CITY OF KIRKLAND
Planning and Building Department
123 Fifth Avenue, Kirkland, WA 98033
425.587.3600 ~ www.kirklandwa.gov

MEMORANDUM

File No.: DRV23-00164

Subject: **MODERA BRIDLE TRAILS
DESIGN RESPONSE CONFERENCE**

PROJECT AS PRESENTED AT DRC I

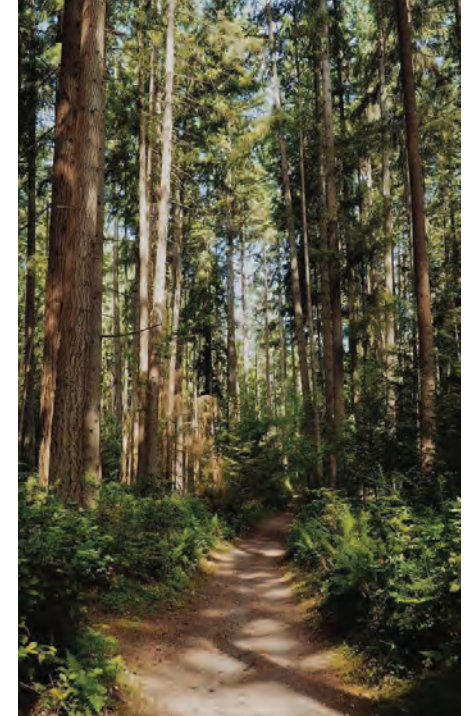
The Design Review Board liked the overall direction of the project, but felt the character of the design could be more precisely fine tuned to reflect the Bridle Trails neighborhood. They wanted to understand more about the design inspirations for the project. The Board suggested art as a way to enhance the through-block pathways and add Bridle Trails specific character elements.

REVISE MATERIAL PALETTE: BOARD GUIDANCE (DRB RESPONSE 2)

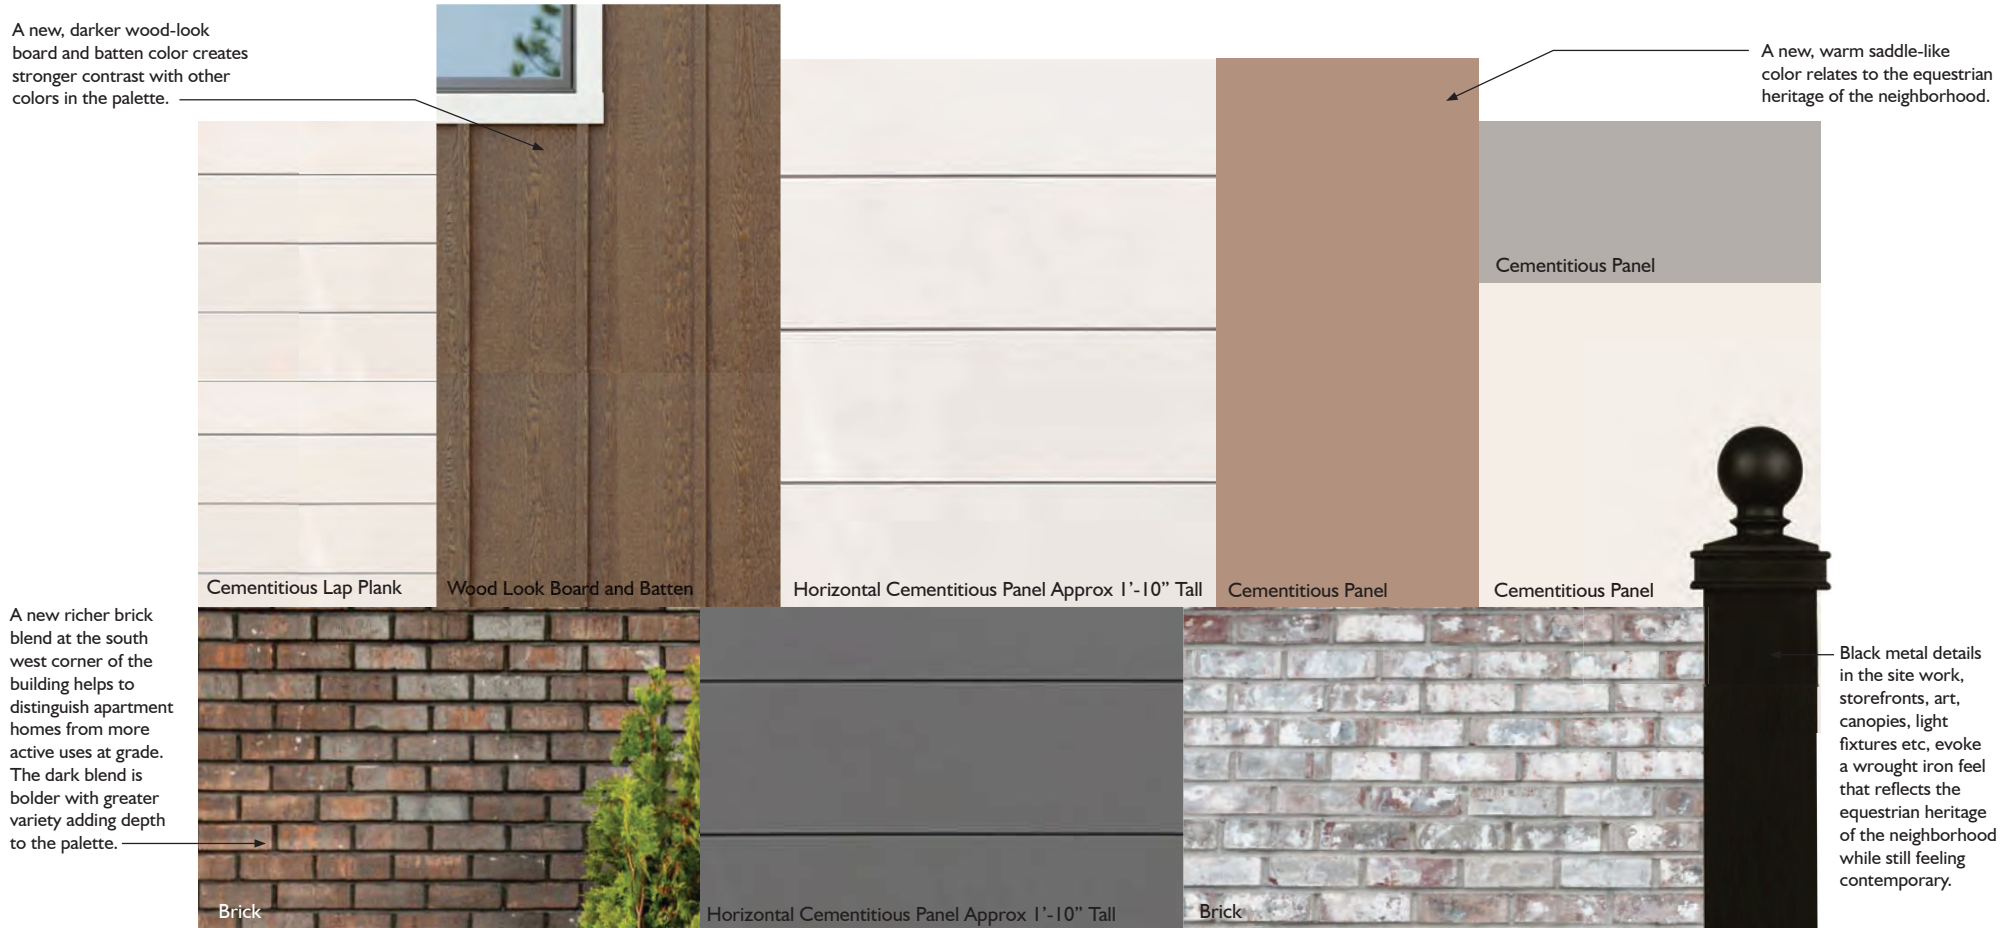
The Board liked the general direction of the materials, but felt the palette was overall too neutral. They wanted to see more depth and richness. They suggested using more than one color for brick.

The updated palette still reflects the sophisticated neutral tones throughout the neighborhood, but makes adjustments for stronger contrast and more warmth. The addition of a second, darker brick blend and a leathery, saddle color add richness and greater variety to the palette.
